Intake air manifold leaking

E31, E38, E39 with M62

Fig. 1: Sealing cover on manifold, rear

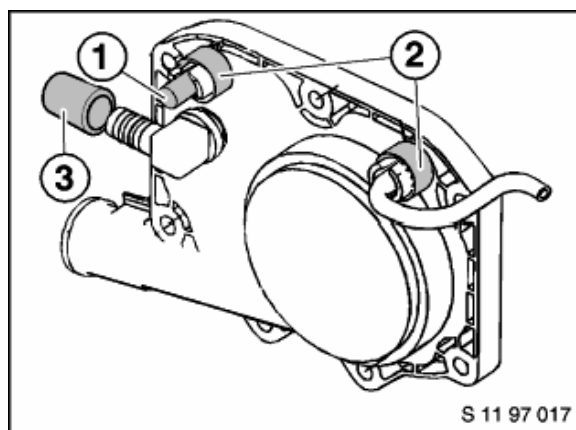
Situation: Leaks in the intake air manifold can adversely affect the idling characteristics of the M62 engine. The fault entry 27 and/or 35 with the fault type "Mixture at the Lambda oxygen sensor too lean" is stored in the DME fault memory. In such cases, the "Check engine" lamp will light up on US vehicles.
Leaks can occur

- at the gaskets between the manifold and the cylinder heads due to the different thermal expansion characteristics of the different components
- at the vacuum connections on the rear end cover of the manifold due to porous sealing caps or connections

- Procedure:**
1. Remove the intake air manifold
Please refer to repair instructions 11 61 050
 2. Replace the sealing cap (1) on the vacuum connection and secure it with a retainer ring (2) (please refer to Fig. 1)
 3. Secure the fuel pressure regulating valve vacuum hose with a retainer ring (2) (please refer to Fig. 1)

Note: The retainer rings (2) should be fitted so that the lugs on the retainer rings point downwards and sit against the sealing cover

4. Renew the sealing cap (3) on the vacuum connection (E31 only) (please refer to Fig. 1)
5. Install the intake air manifold using new gaskets
